From: [REDACTED]
To: [REDACTED]
CC: [REDACTED]
Sent: 2/24/2021 9:33:33 AM
Subject: RE: O8W-PM [REDACTED] - Bucks Creek 1101 Phase 1,2&3 - Pre-Engineering Meeting

Bucks Creek 1101- PM# [REDACTED] Overview Map

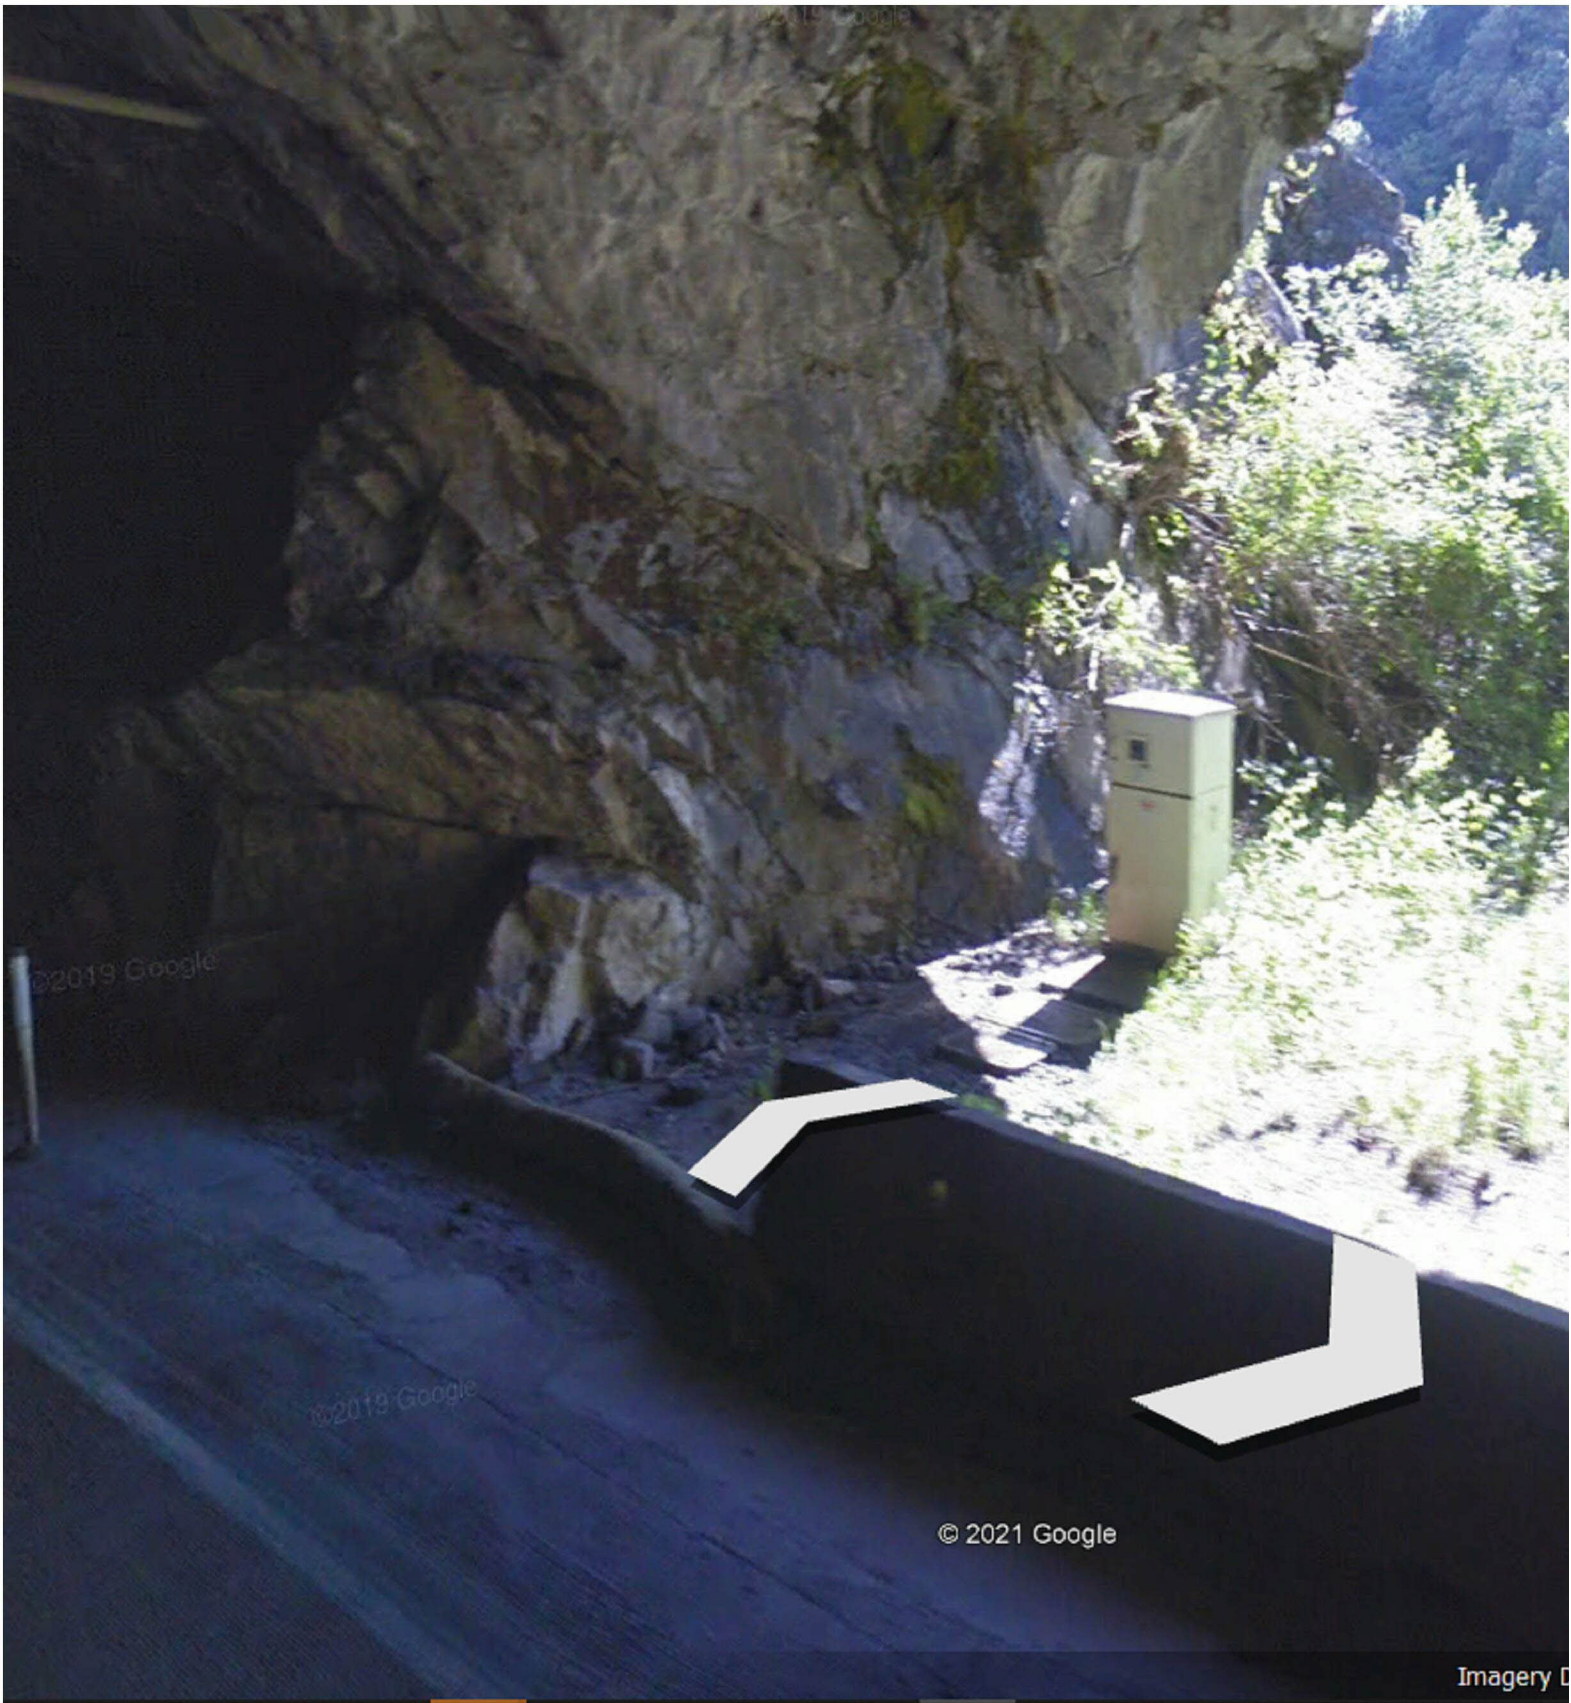
Attached are the 'base-map' limits in a kmz. file. As you will see, we need our base-map to go about ~100' into the tunnel at the south end (see pedestal in picture below....please begin about ~50 beyond this point which is about ~100' beyond the Cresta Dam).

We want to end the base-map at the sign location below which is roughly at MM (Mile Marker) 5.10.

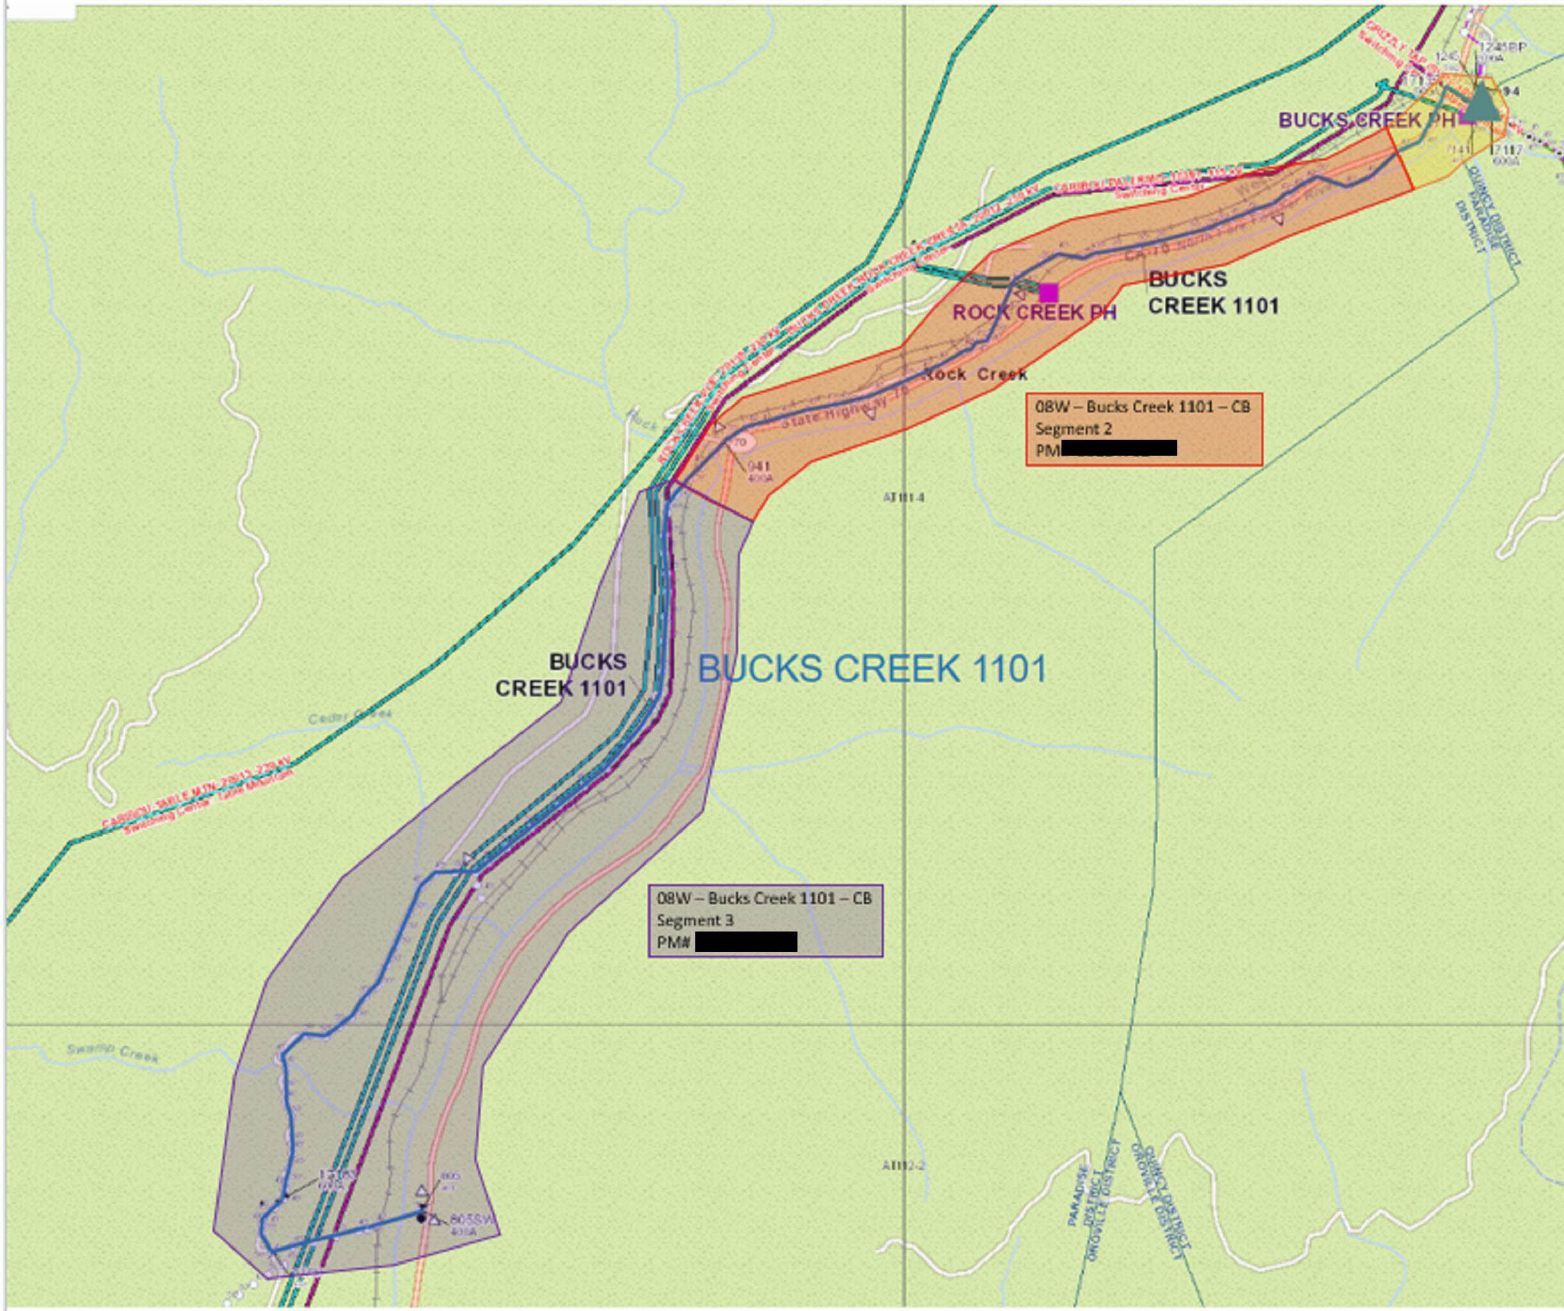
For Bucks Creek there is quite a bit of work surrounding Hwy 70 and we will need a Land Department Base Maps prepared for all 3 Orders. This will delay the EOD dates until these can be developed and provided to the Vendor... We will also need answers to the questions outlined by [REDACTED] below...
